## SPECIAL MAINTENANCE INSTRUCTION No.

RDSO /2006 /EL/SMI/0242, REV. 3 Dated 02.02.2023

Maintenance Practices of Under slung Compressor mounted on WAP-5, WAP-7 & WAG-9/WAG 9H/HC class of Electric Locomotive to avoid falling down of the compressor unit on line. Standardization of safety wire rope arrangement of under slung compressor mounted on WAP-5, WAP-7 & WAG-9/WAG 9H/HC class of Electric Locomotive.

**SKETCH FOR THE PROVISION OF SAFETY WIRE ROPE FOR UNDERSLUNG  
MOUNTING OF COMPRESSOR MODEL RR20100, RR20100 CG(M), RR20100 CC ,  
2A320D & RR1750 OF 1745 LPM CAPACITY**

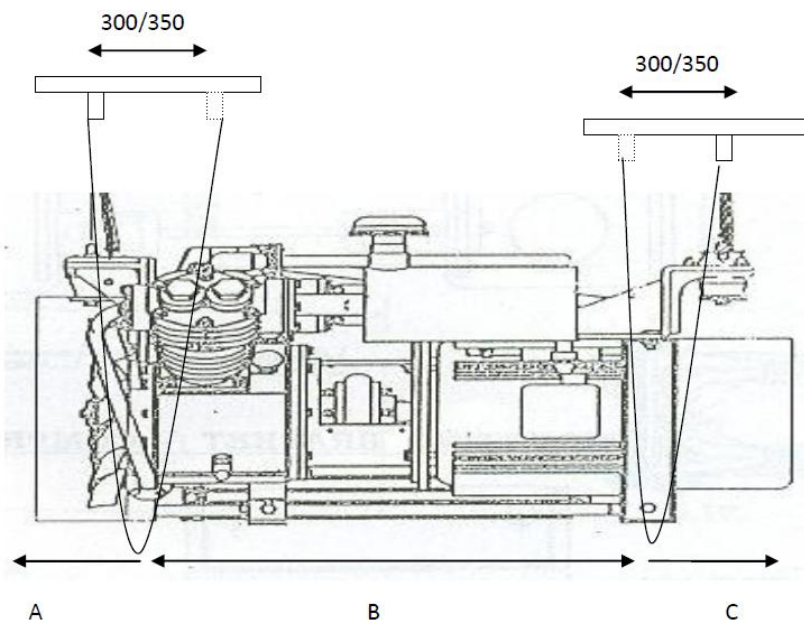
The Sketch for the provision of safety Wire rope is attached as Annexure –III

- i) Safety Wire rope is free from any tendency to kink.
- ii) The safety wire rope should not bend around any sharp corners that might damage the rope or reduce its effective strength.
- iii) The length of the safety wire rope should be so adjusted to avoid the weight of the motor compressor unit coming on the safety wire rope directly.
- iv) Whenever locomotive touches the shed the sling must be checked for its proper condition

S.no.	Dimension	ELGI (RR20100)	FTRTIL(2A320D)	AIMPL (RR1750)
1	A	130±5 mm	130±5mm	130±5mm
2	B	1210±10mm	1210±10mm	1210±10mm
3	C	130±5mm	130±5mm	130±5mm

1. Safety Wire Rope Nominal dia 8 mm as per IS : 2266:2002
2. The size of pressed Angle should be 65x50x10 mm thick, with bending radius- R15. Bracket Assembly should be as per drawing No. 1209-02.427-424 or latest.
3. No. of Angle plate per loco-08 Nos.
